The South Jericho Residents' Association (SJRA)

Planning Application No.13/00832/FUL
Former Ruskin College Site, Walton Street, Oxford
Response to letter from Turnberry Planning dated August 20th 2013

On behalf of the South Jericho Residents Association (SJRA) I write in response to the letter submitted by Turnberry Planning on the 20th August attempting to clarify the technical aspects of the proposed scheme. The SJRA has met to discuss the feedback from Turnberry Planning and our response is set out below.

Appendix 1: Glass Dormers on the fourth floor

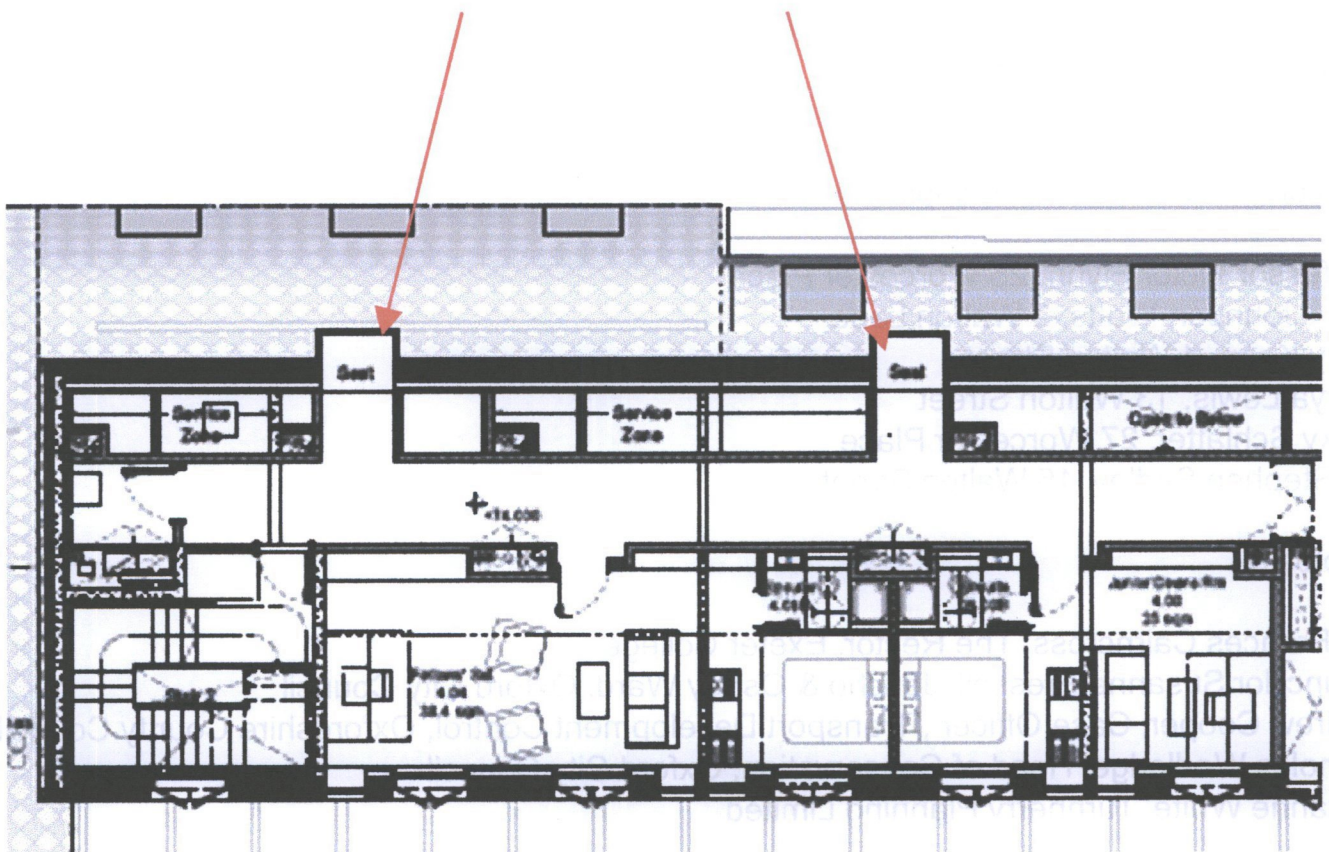
- the glass dormers are unsuitable for an **already very high frontage** overlooking a narrow residential street
- these are intended as waiting rooms for students awaiting Tutorials and, in our view, should be replaced with **roof lights that are flush with the surface** with seats placed within the internal corridor instead
- we think these protruding dormer windows are a significant concern because they are effectively **all-year roof terraces**
- Turnberry Planning omitted to explain the nature and purpose of the glass dormer in any of their presentations

Appendix 2: Outside roof terrace

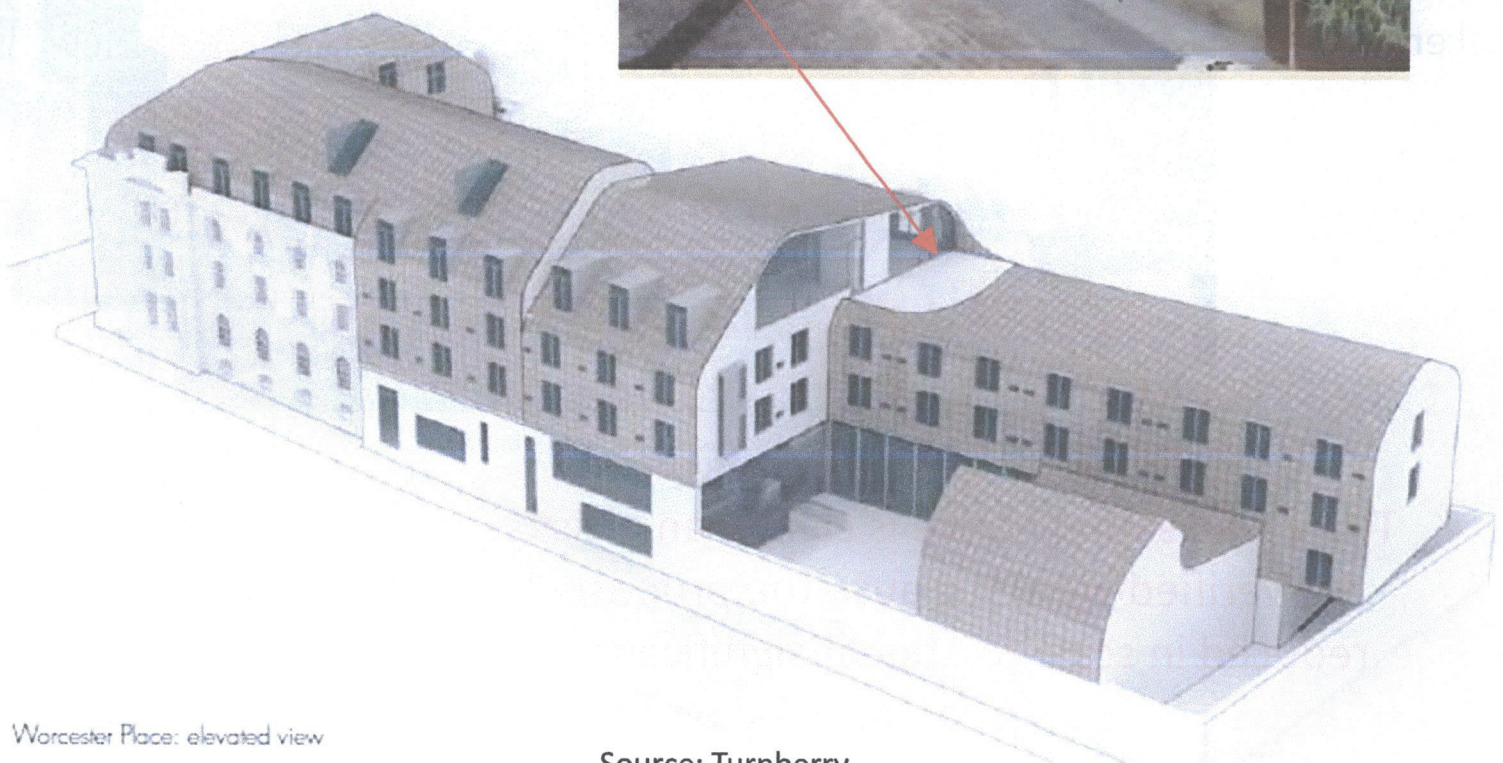
- the screening (mentioned by Turnberry Planning in their letter) should be a **solid permanent barrier** high enough to ensure privacy for the residential houses opposite
- this should also be **designated a quiet area** with no noise permitted after 10pm, with no **music** to be played at any time, no **alcohol** and no **parties**
- we have a particular concern with Summer Schools
- Turnberry Planning omitted to mention the roof terrace in any of their presentations

Appendix 4: The view facing west from the junction of Worcester Place and Walton Street

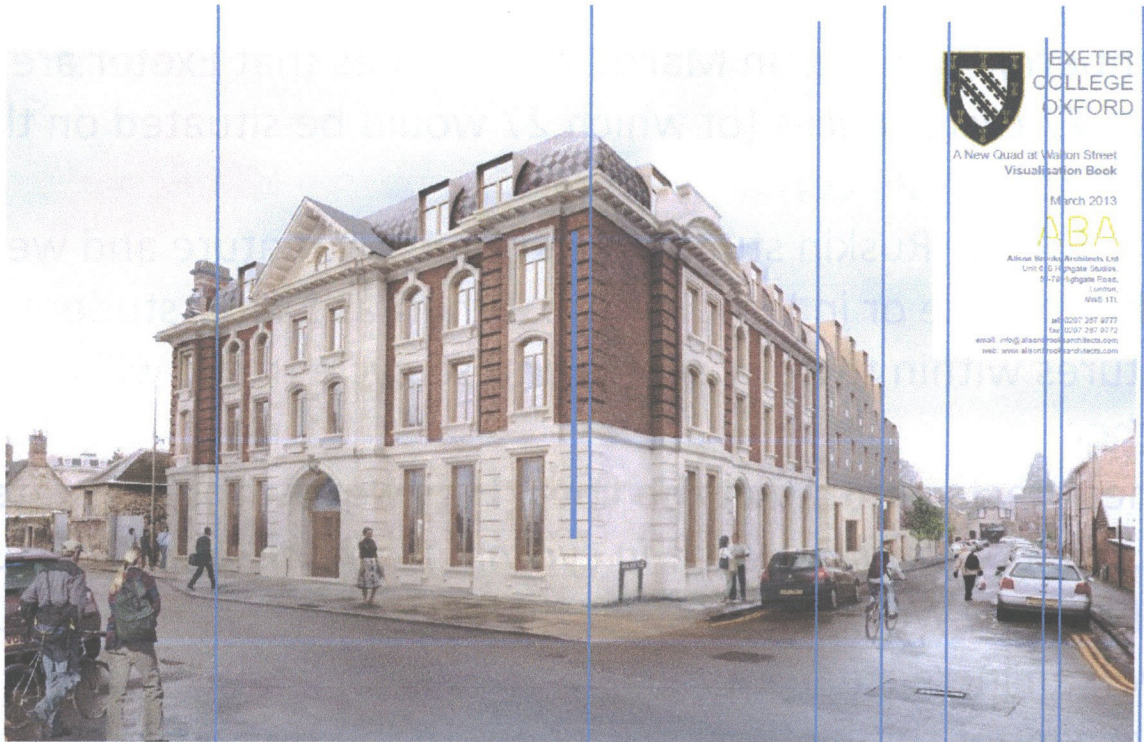
The visualisation above is clearly an artist's impression, and not a verified view, because the proposed building has been reduced in scale to appear significantly smaller than it would actually be once built

Appendix 6: Angles and height measurements presented by Turnberry Planning

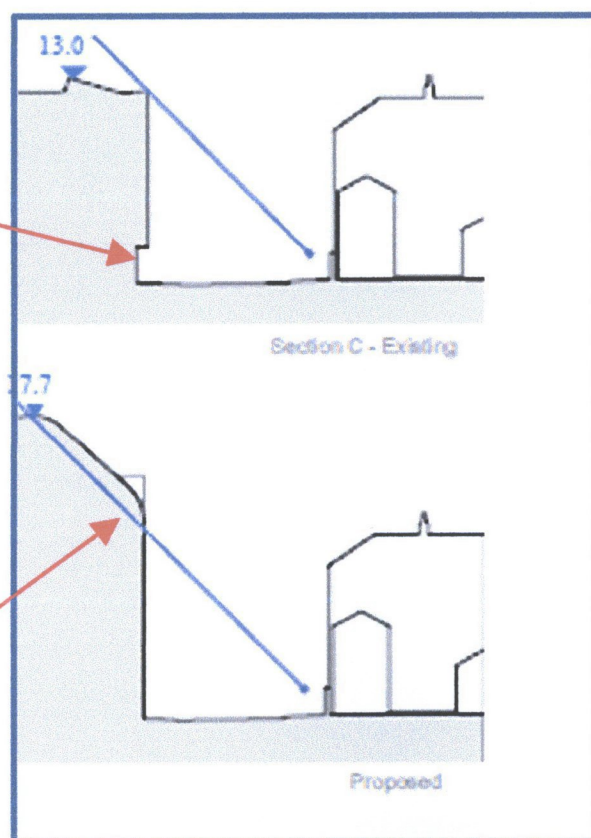
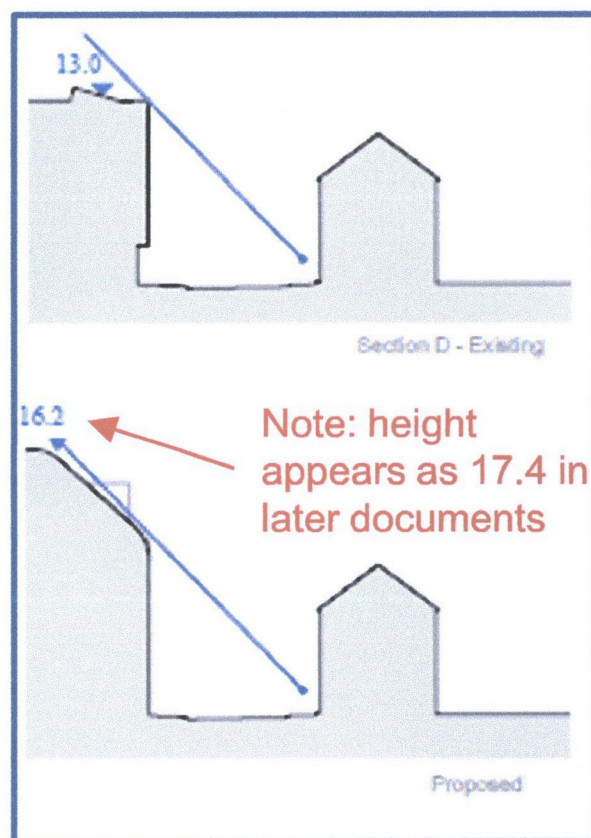
Additional width of protruding windows has been assumed

Angle is greater even though effect of dormer windows is not included

Note: height appears as 17.4 in later documents
